TECHNICAL BULLETIN

JTB00191NAS2
12-DEC-12

Glove Compartment Lid not Damped When Opening

XK (X150)

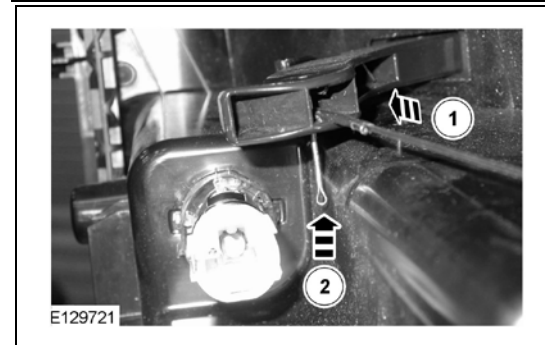
1. Refer to Workshop Manual section 501-12 and remove the glove compartment.
2. Drill a 2mm hole through the glove compartment damper arm (shaded area).

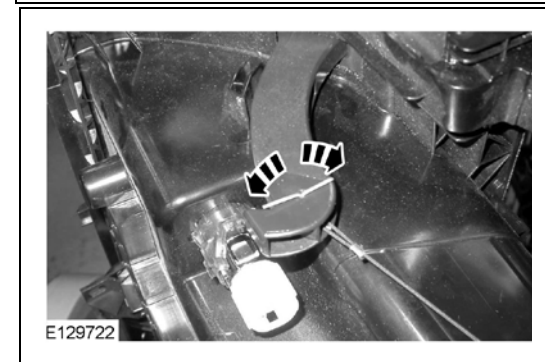
3. Install the glove compartment lid damper cord looped (①) end into the damper arm.
4. Install the split / cotter pin (②) into the hole and through the damper cord looped end.

5. Fold the protruding ends of the split / cotter pin.
